Upper Swan - Proposed Structure Plan SP/2016/003

I object to the proposed development unless the following issues are taken care off ¹

Fig. W-2

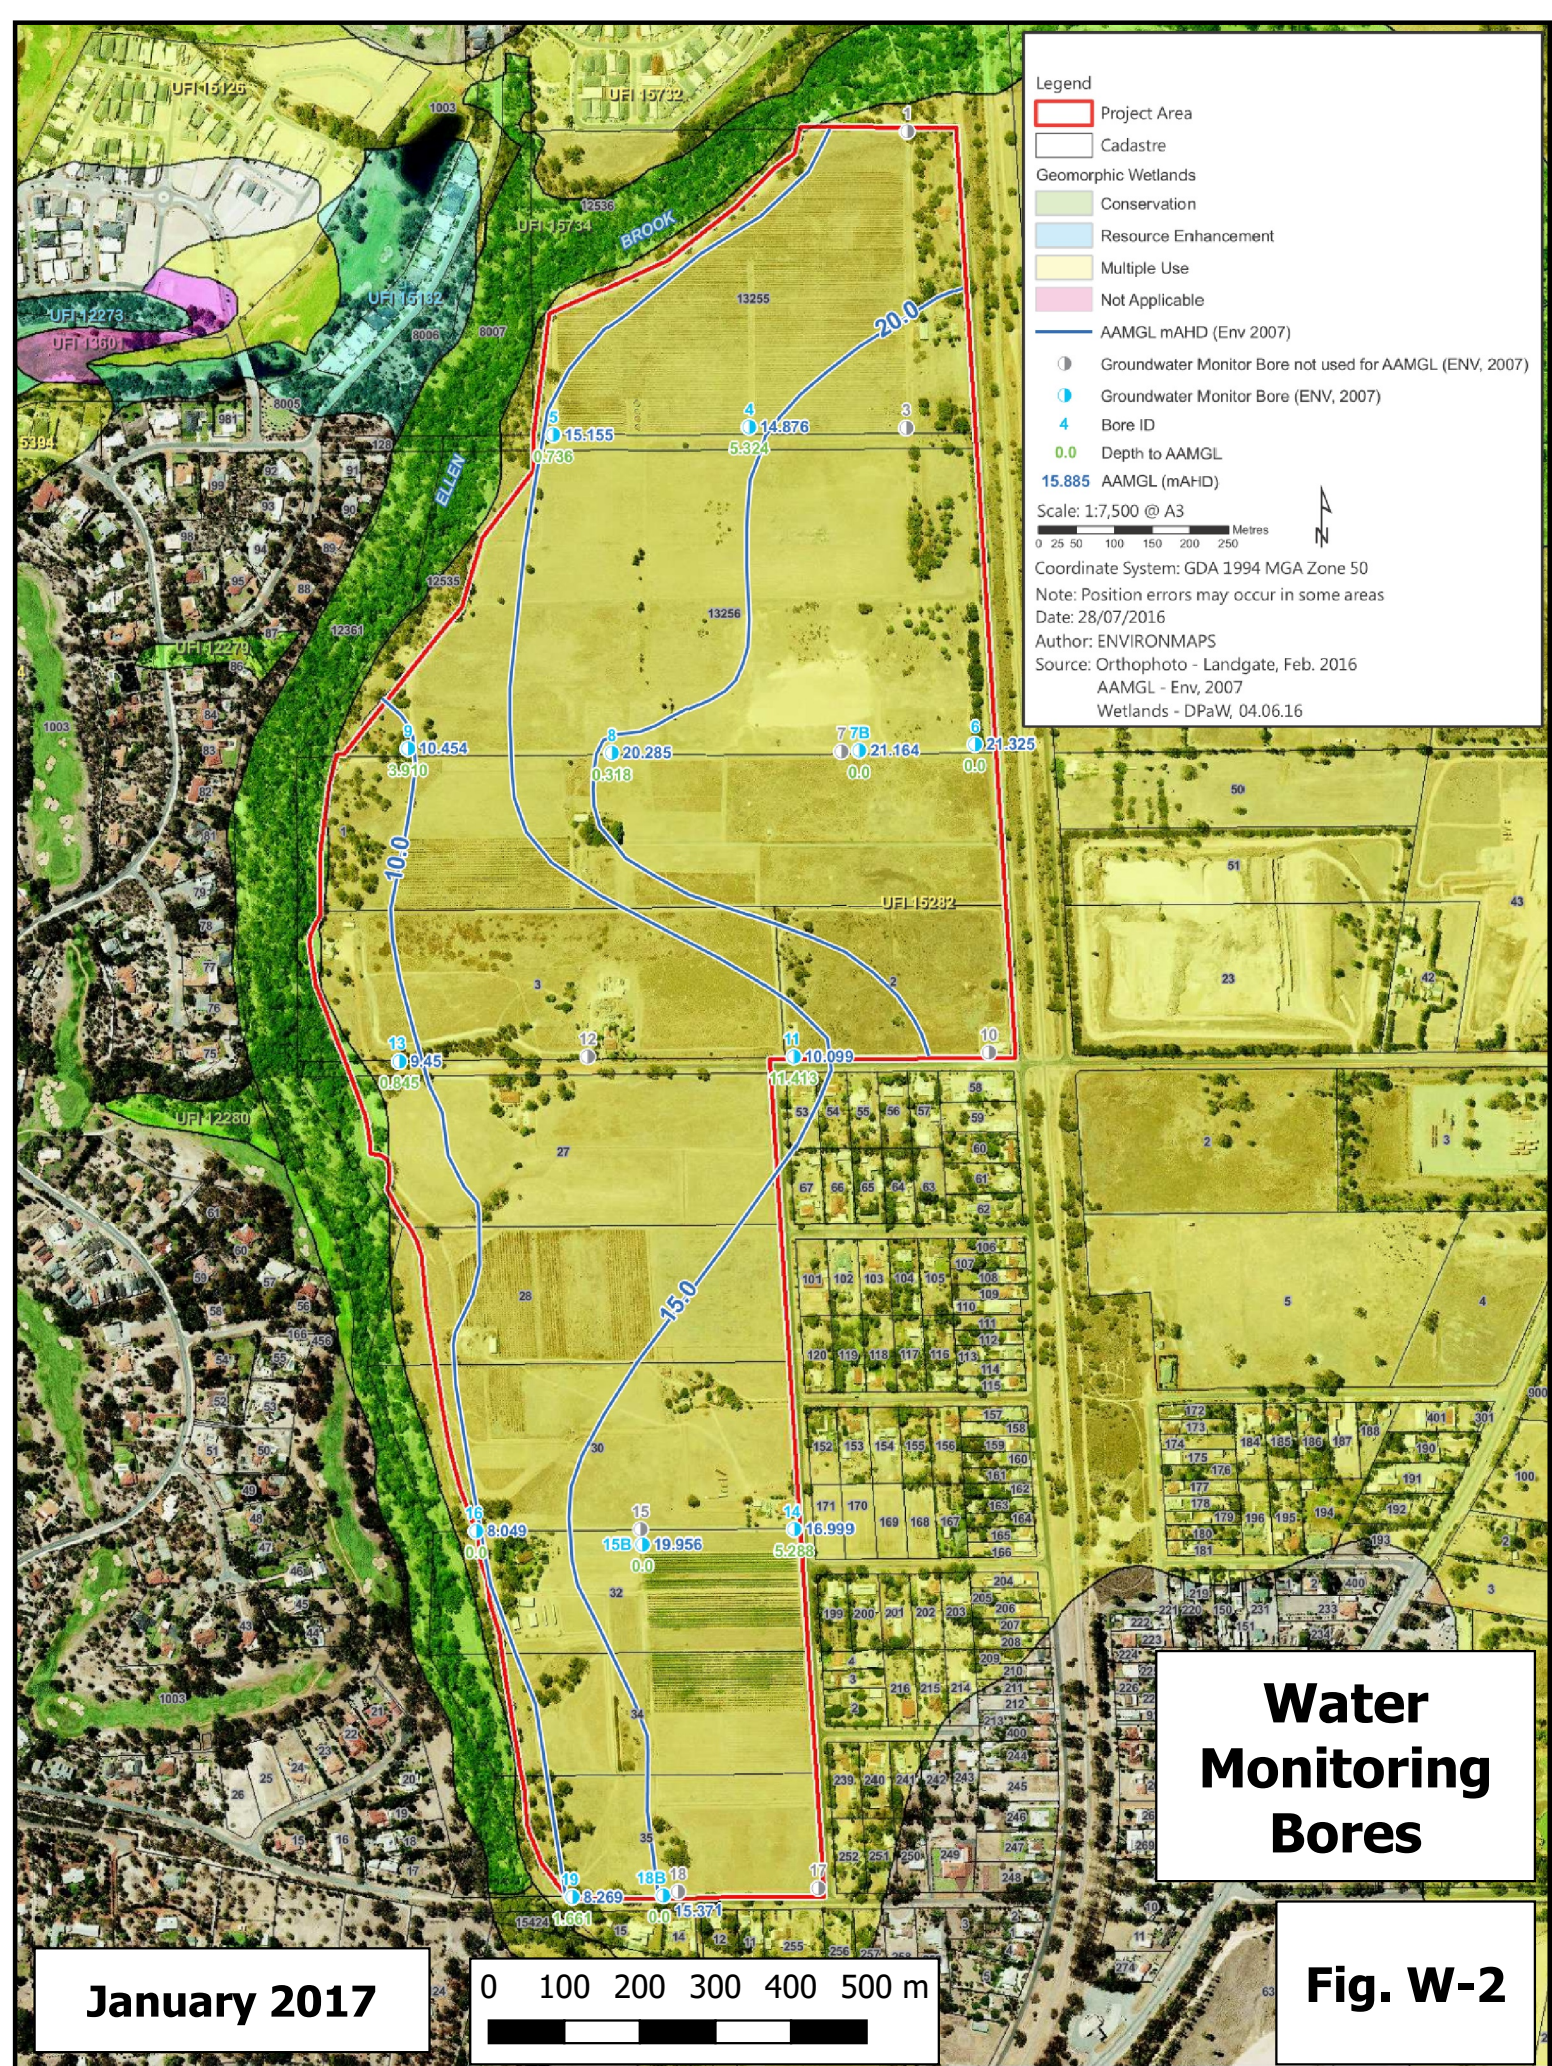
Part-2 of report (Attachment 10) shows in Fig 18 the potential of waterlogging in certain spots of the USLPL (Fig. W-2). This corresponds with fig 3-7 (Attachment 10) of part-1 of the report, which shows very shallow Average Annual Maximum Groundwater Levels (shown here in fig W-1). This data overlain on to the target residential design is shown in figure W-3. The question is how is the developer going to deal with this problem.
